8x930Ax (8x930AD, 8x930AE) SPECIFICATION UPDATE

Release Date: February 1999

Order Number: 272940-017

Figure 3. Delay Circuitry

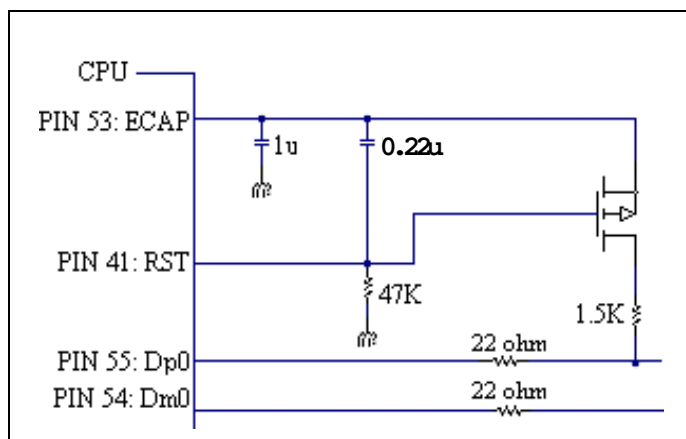
WORKAROUND: (design impact) Insert a MOSFET on the Dp0 line delaying the energizing of the pull-up resistor by about 8mS. The circuit inserts a 5 to 8 millisecond delay in powering Dp0 thus eliminating the SE1 caused by power-on transients during the power-on reset of the 8x930. See Figure 3 for details.

ITEM: The capacitor value in Figure 3. Delay Circuitry, in Errata 9806001 of this specification update has changed. The capacitor value is 0.22 μ , not 0.23 μ .

Figure 4. External Code Fetch, Nonpage Mode

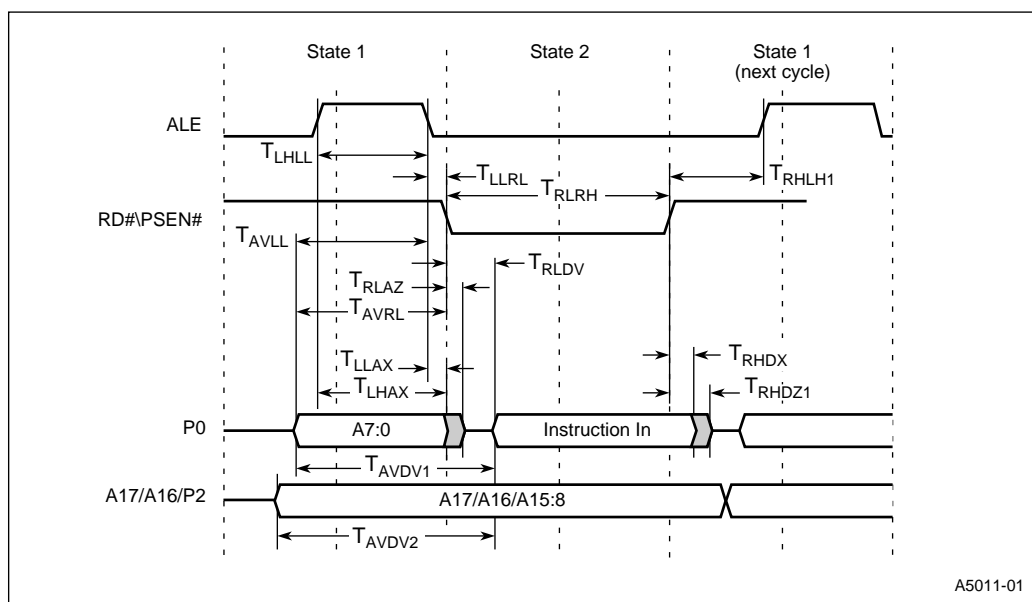
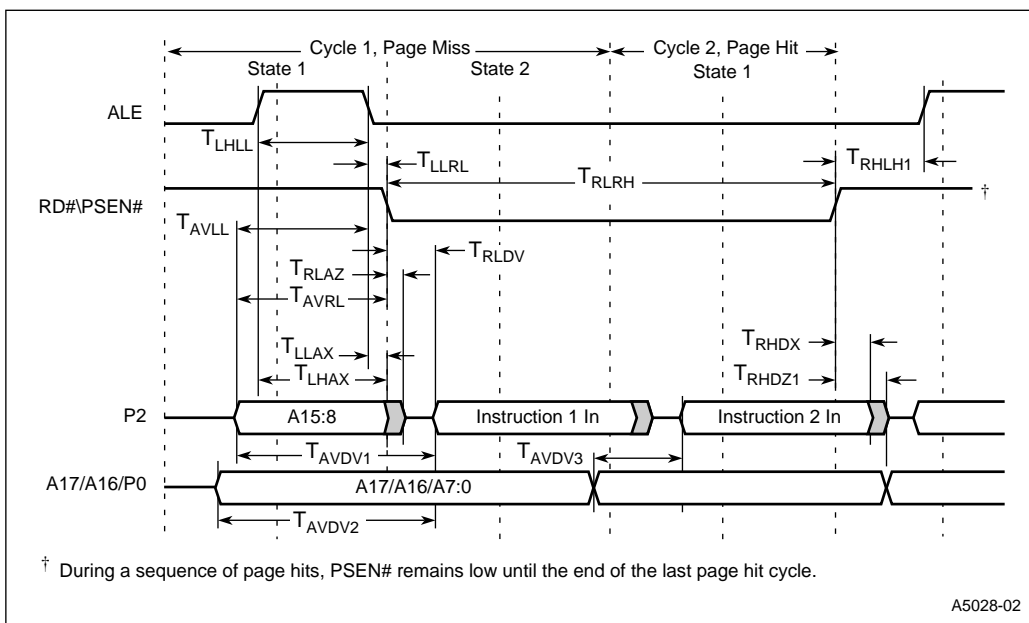
PROBLEM: The T_{RHDZ1} (Instruction Float After RD#/PSEN# High) specification on the 8x930Ax when operating at 12 MHz is 10 ns. However, a slow memory device such as an EPROM typically takes approximately 30 – 90 ns to float its output. (This specification, generically called T_{PHZ} , may vary depending on the memory type and manufacturer.) Figure 4 and Figure 5 illustrate the T_{RHDZ1} timing.

The difference between the T_{RHDZ1} and T_{PHZ} specifications causes contention on the data bus (P0 in nonpage page, P2 in page mode). The 8X930Ax begins to drive the address for the next bus cycle while the memory device is still driving data from the previous bus cycle.

To prevent this contention, designers can use a buffer to isolate the output of the memory device from the data bus (port 0 or port 2) of the 8x930Ax. This will prevent the memory device from driving the data bus during the critical period after T_{RHDZ1} expires. We suggest a buffer such as the 74F541 octal, three-state line driver shown in Figure 6.

Figure 6. Example Bus Contention Solution for 8X930Ax (Nonpage Mode)

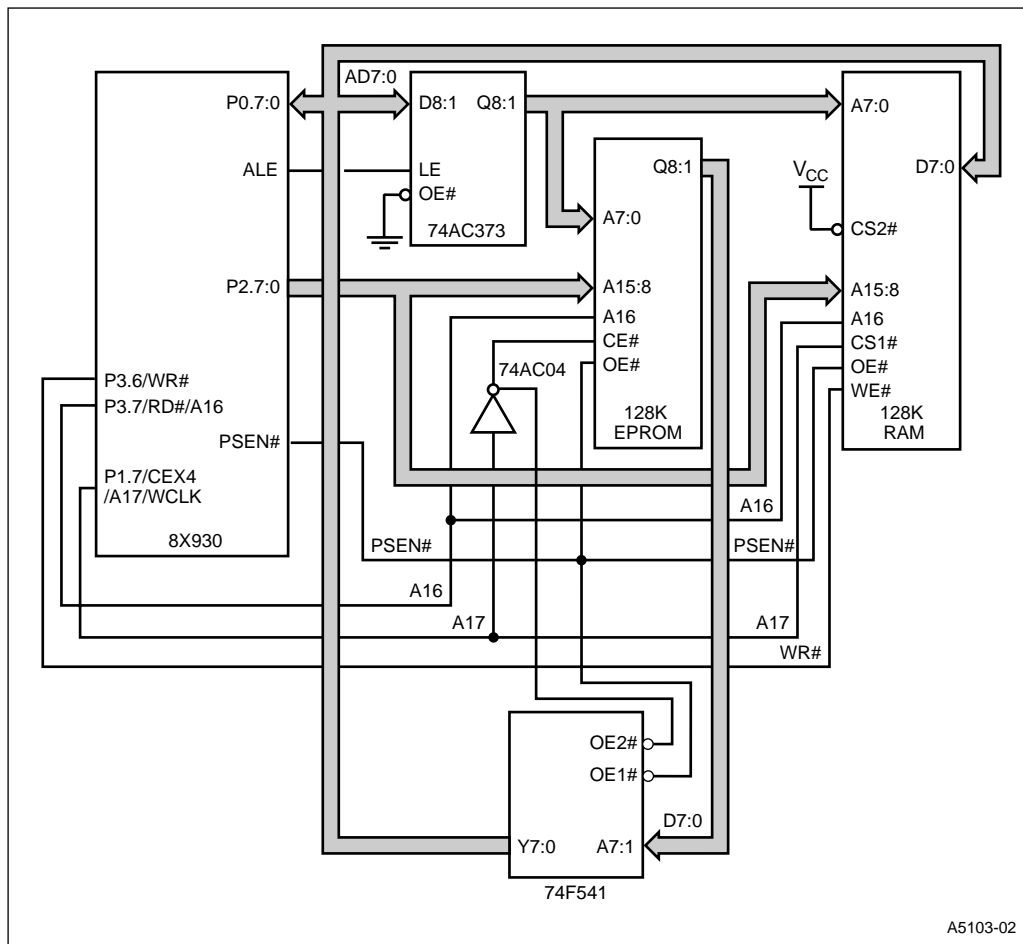
Figure 6 illustrates the connections of an 8X930Ax configured for nonpage mode with EPROM and RAM in external memory. If your system uses a different configuration, your circuit will be different from the example. The 74F541 is enabled to pass data from the EPROM to the 8X930Ax (port 0) when OE1# and OE2# are active. Table is a truth table for the 74F541.
